**Origination Form**  
Proposed Revisions to a Standard Plans Index

<b>Originator:</b>	Stepp, Richard	<b>Index Number:</b>	102-110
<b>Date:</b>	10/18/2024	<b>Sheet Number(s):</b>	1,4, 7-10
<b>E-mail:</b>	richard.stepp@dot.state.fl.us	<b>Index Title:</b>	Type K Temporary Concrete Barrier System

LAST REVISION 11/01/25	REVISION	DESCRIPTION:	 FY 2026-27 STANDARD PLANS	TYPE K TEMPORARY CONCRETE BARRIER SYSTEM	INDEX 102-110	SHEET 1 of 17
------------------------------	----------	--------------	--	--	------------------	------------------

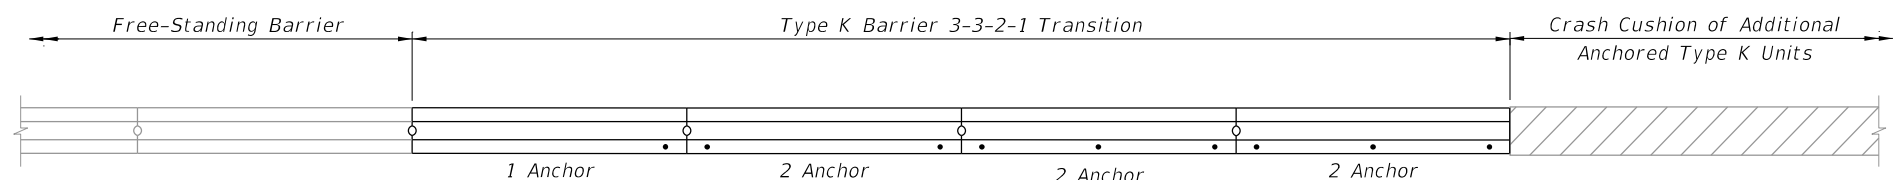
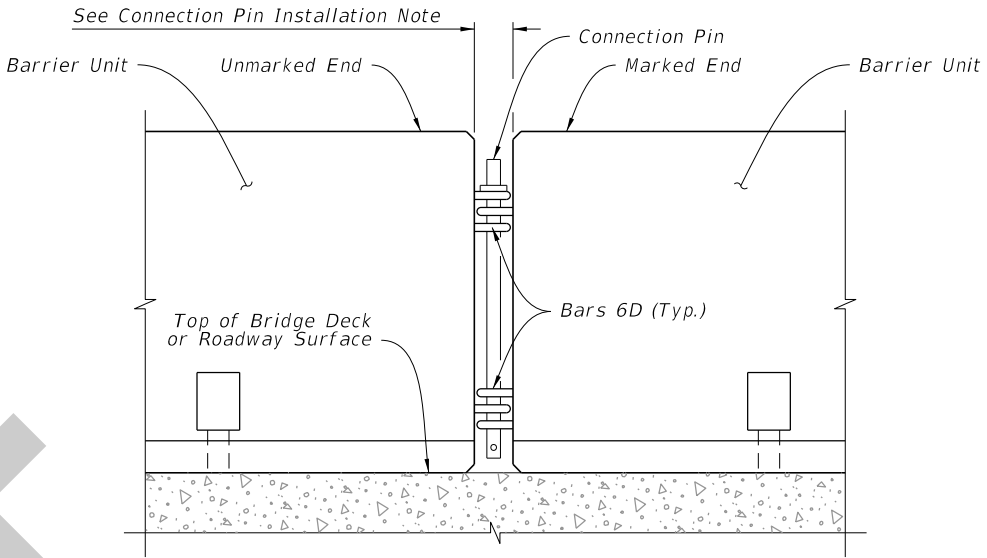
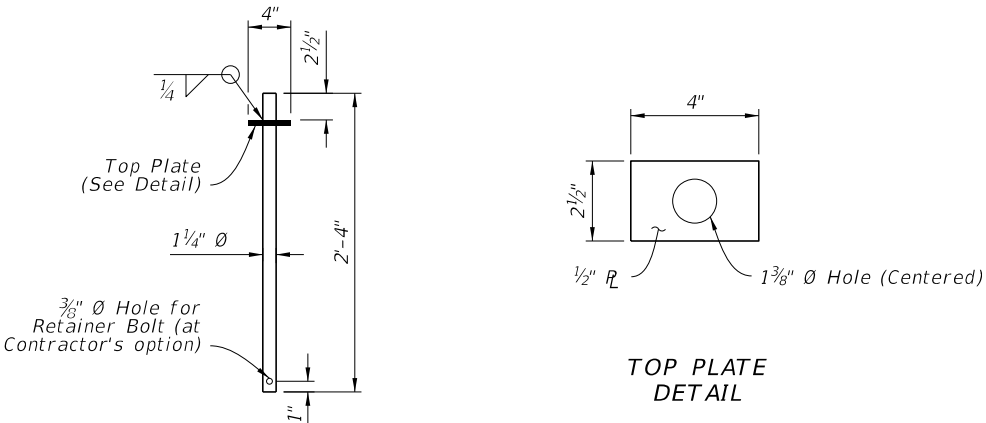
Sheet 1: General Notes - Rename "THRIE-BEAM GUARDRAIL SPLICE INSTALLATION NOTES" to "CONNECTION TO PERMANENT RIGID BARRIER NOTES". Added a new Note 1 to reference sheet numbers with splice connections and define barrier nomenclature. Incremented previous note numbers to account for the new Note 1;

1. For splice connection details between Type K Temporary Concrete Barriers and Permanent Traffic Railings, see Sheets 7 thru 10. Within this Index, the term Traffic Railing also applies to Concrete Barrier, where both terms refer to permanent installations shown in the Index 521 series.

CONNECTION TO PERMANENT RIGID BARRIER NOTES:

1. For splice connection details between Type K Temporary Concrete Barriers and Permanent Traffic Railings, see Sheets 7 thru 10. Within this Index, the term Traffic Railing also applies to Concrete Barrier, where both terms refer to permanent installations shown in the Index 521 series.

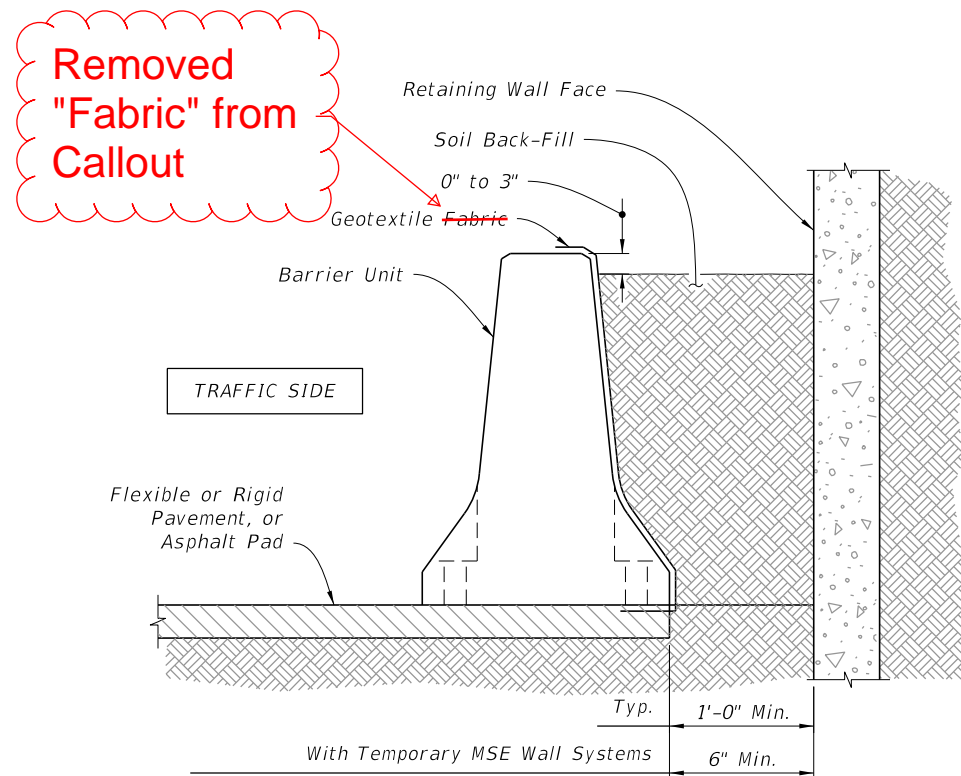
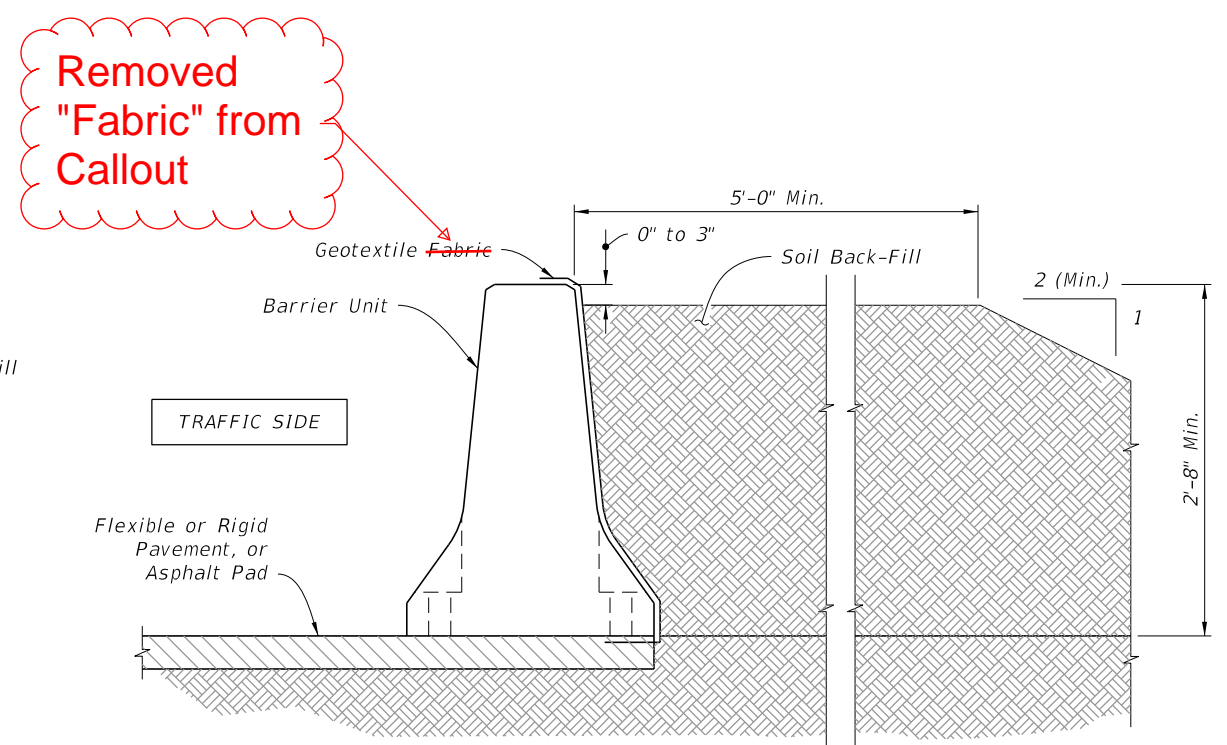
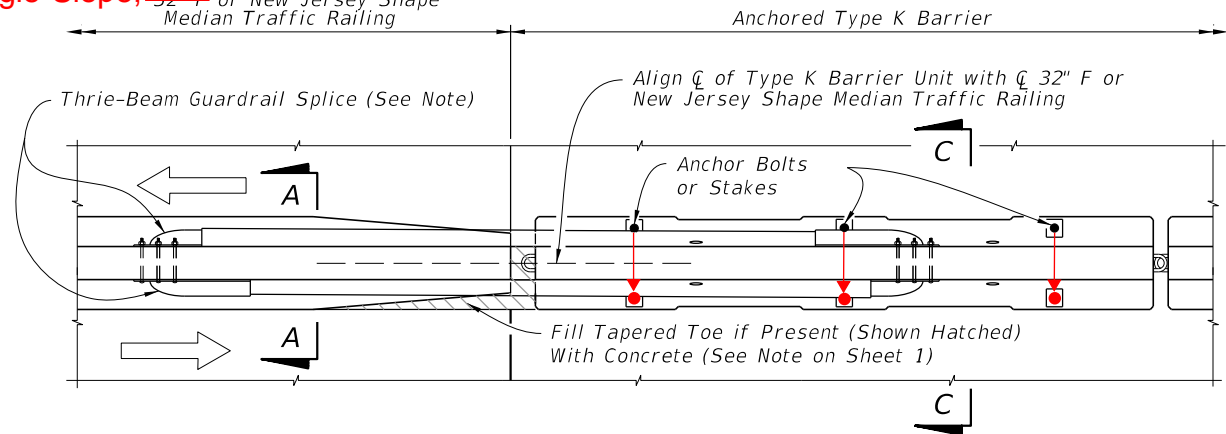
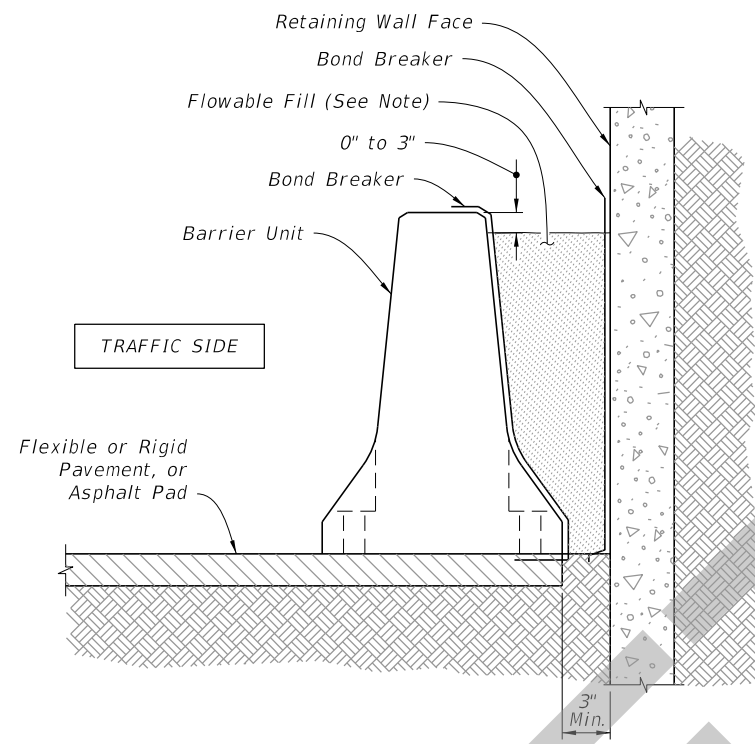
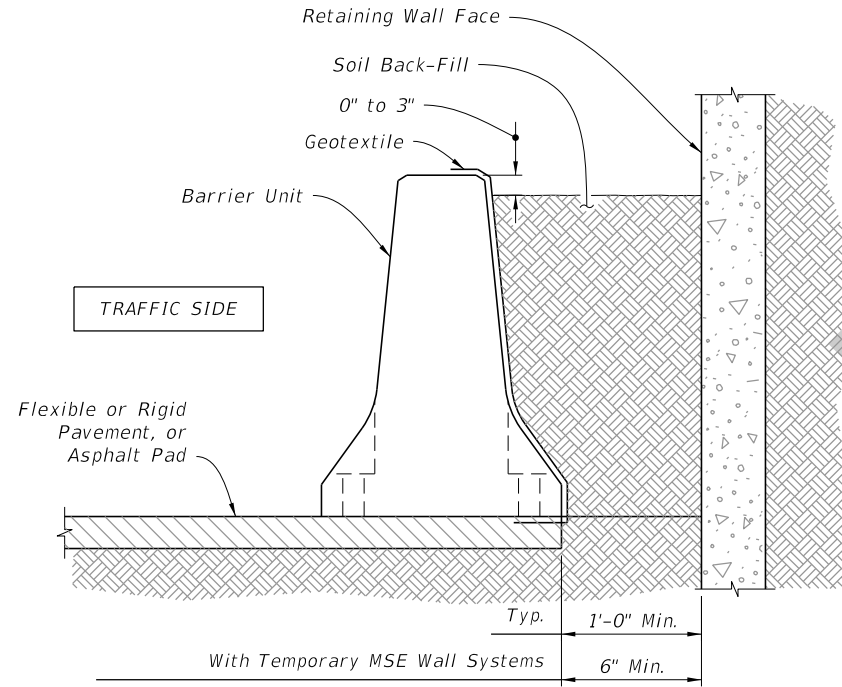
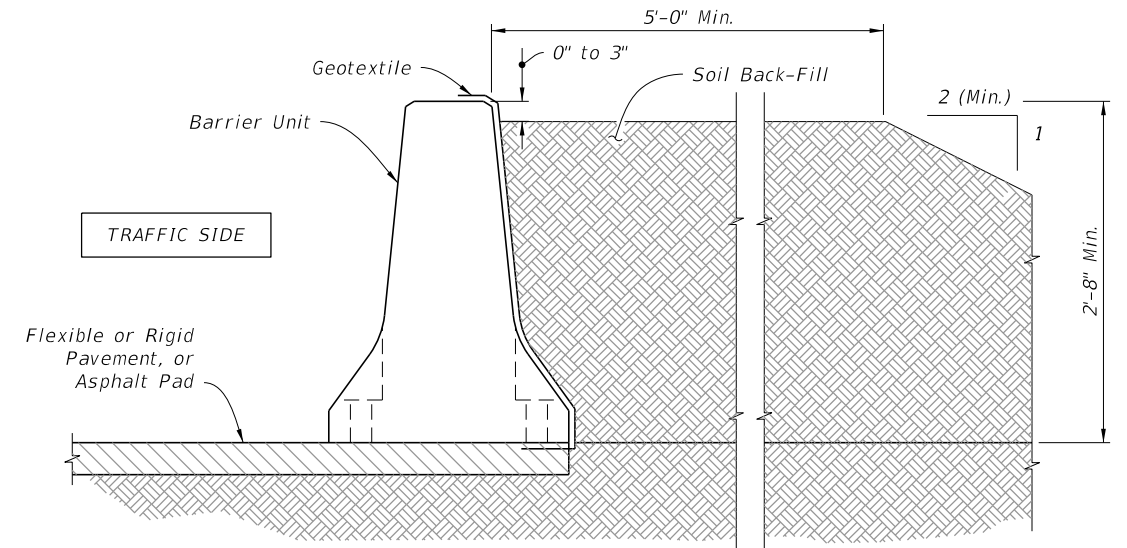
Sheet 4: Deleted "Fabric" from "Geotextile Fabric" callout on Typical Section details;

Also, per a revision request from the State Materials Office, the word "fabric" is being removed from "geotextile" callouts.

**GEOTEXTILE:** Provide and install Type D-5 geotextile in accordance with Specification 514 to contain Back-Fill Material behind the Barrier Units. Geotextile may be continuous over the length and height of the installation or may be individual pieces as required to cover the Lift/Drain Slots and open vertical joints between Barrier Units.

PARTIAL PLAN VIEW AT MEDIAN TRAFFIC RAILING

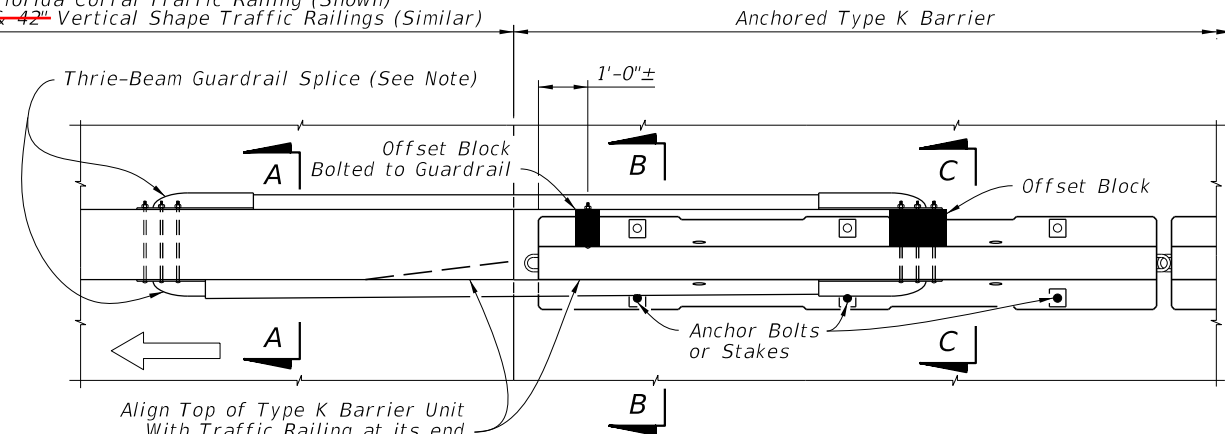
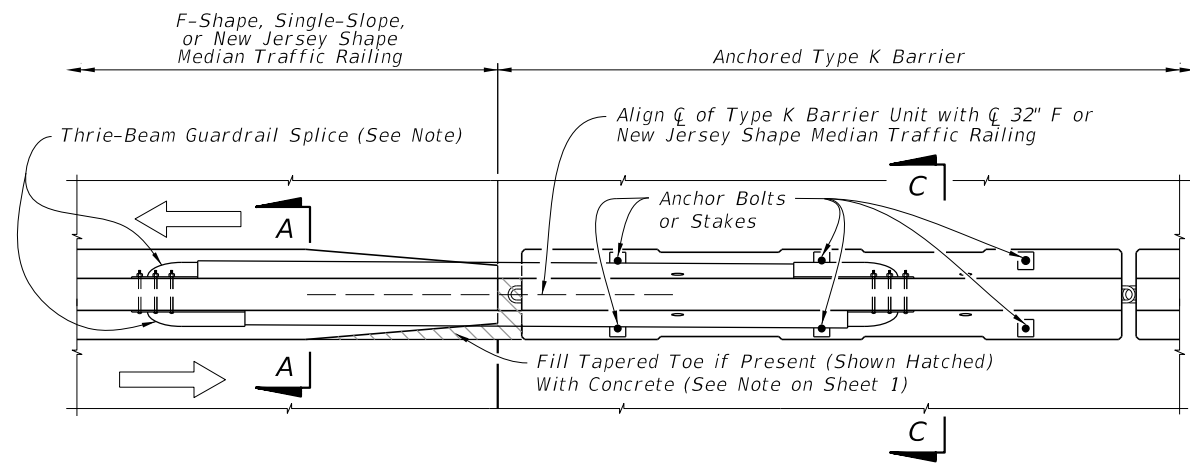
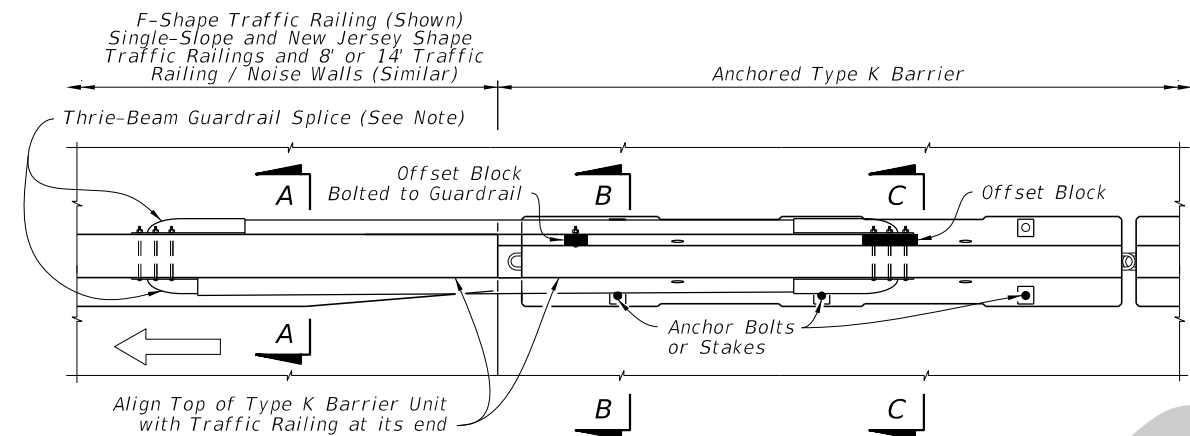
Sheet 7: In the Partial Plan View at Median Traffic Raining, added anchor call outs on both sides of the barrier for consistency with Sheet 6;

F-Shape, Single-Slope, ~~32" F~~ or New Jersey Shape Median Traffic Railing

LAST REVISION <del>11/01/17</del>	DESCRIPTION: 11/01/25	FDOT	FY <del>2025-26</del> 2026-27 STANDARD PLANS	TYPE K TEMPORARY CONCRETE BARRIER SYSTEM	INDEX 102-110	SHEET 7 of 17
--------------------------------------	--------------------------	------	---	--	------------------	------------------

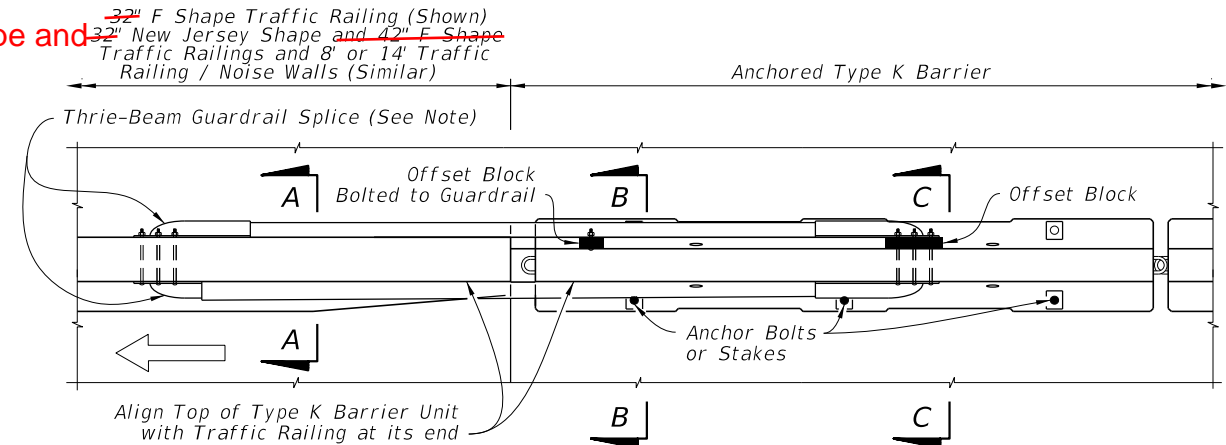
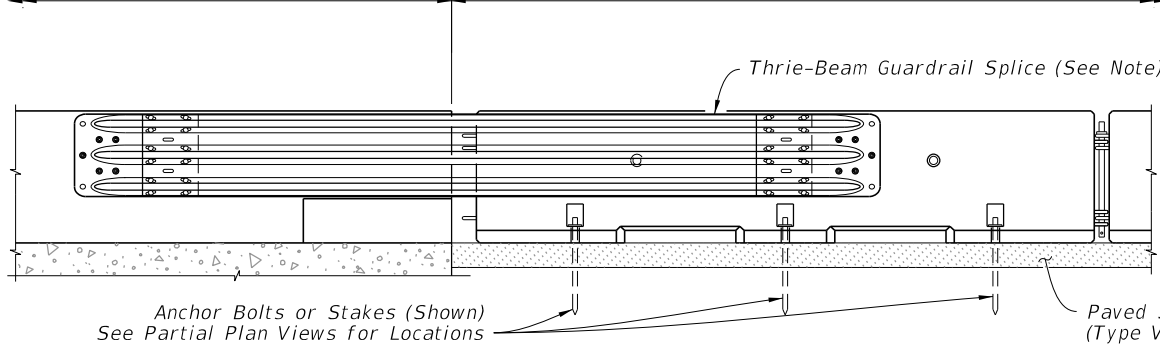
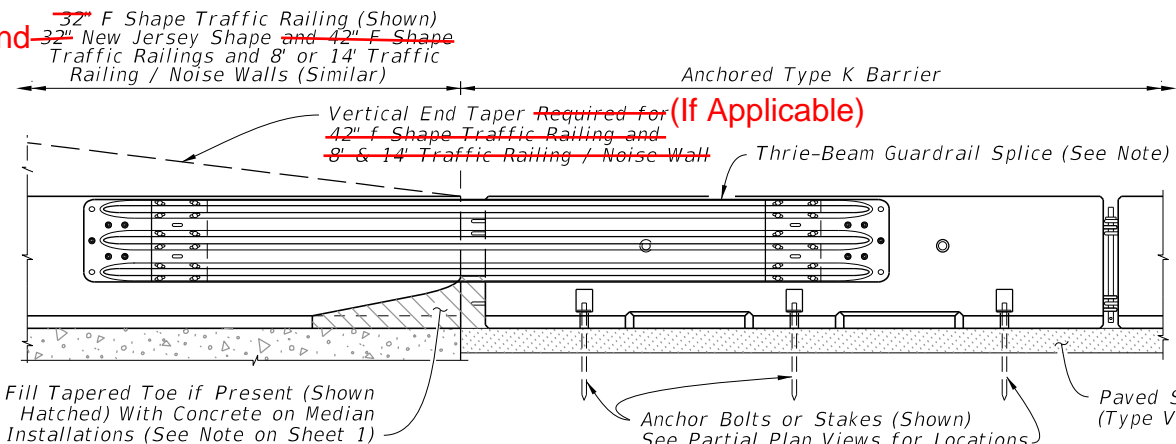
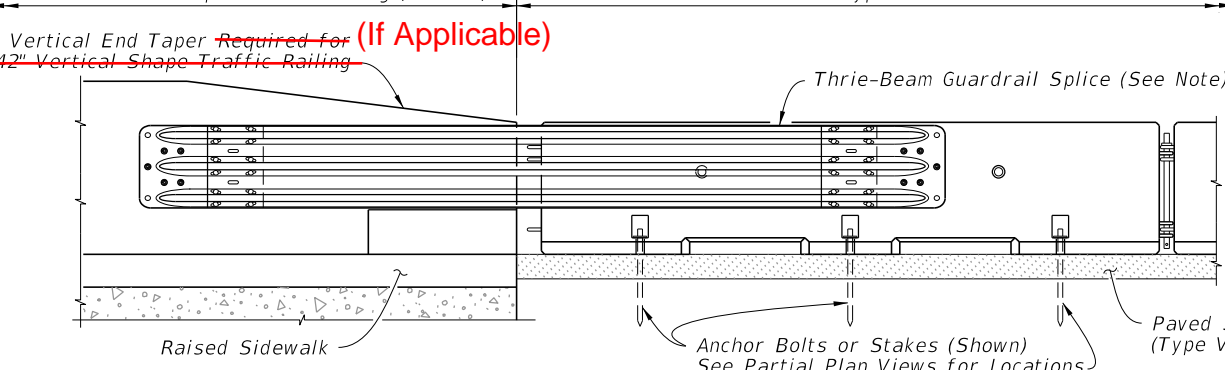
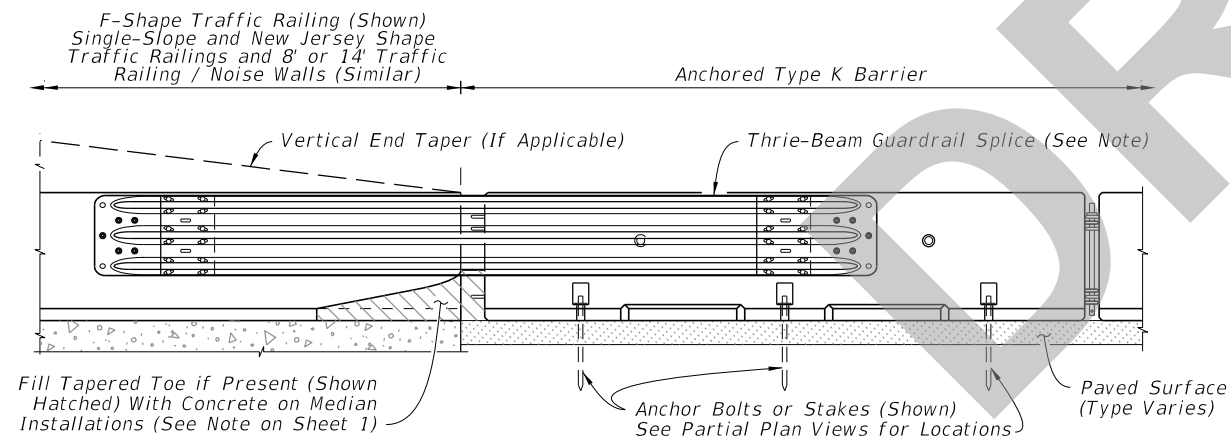
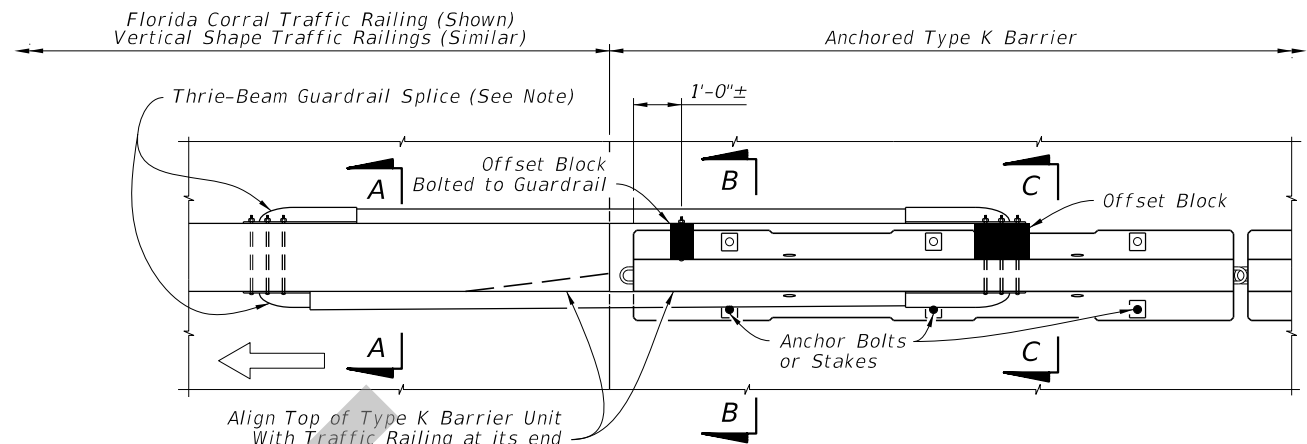
Sheets 7-10: Revised detail labels to simplify and include "Single-Slope" Traffic Railings and Concrete Barriers where applicable

Single-Slope and ~~32" F Shape Traffic Railing (Shown)~~  
~~32" New Jersey Shape and 42" F Shape Traffic Railings and 8' or 14' Traffic Railing / Noise Walls (Similar)~~

Single-Slope and ~~32" F Shape Traffic Railing (Shown)~~  
~~32" New Jersey Shape and 42" F Shape Traffic Railings and 8' or 14' Traffic Railing / Noise Walls (Similar)~~

For Single-Slope, F-Shape,

APPROACH TRANSITION SPLICE DETAIL  
FOR ~~F~~ AND NEW JERSEY SHAPE TRAFFIC RAILINGS AND 8' & 14'  
TRAFFIC RAILING / NOISE WALLS (CONCRETE BARRIER ~~WALL~~ SIMILAR)

**APPROACH TRANSITION SPLICE DETAIL  
FOR SINGLE-SLOPE, F-SHAPE, AND NEW JERSEY SHAPE TRAFFIC RAILINGS AND 8' & 14'  
TRAFFIC RAILING / NOISE WALLS (CONCRETE BARRIER SIMILAR)**
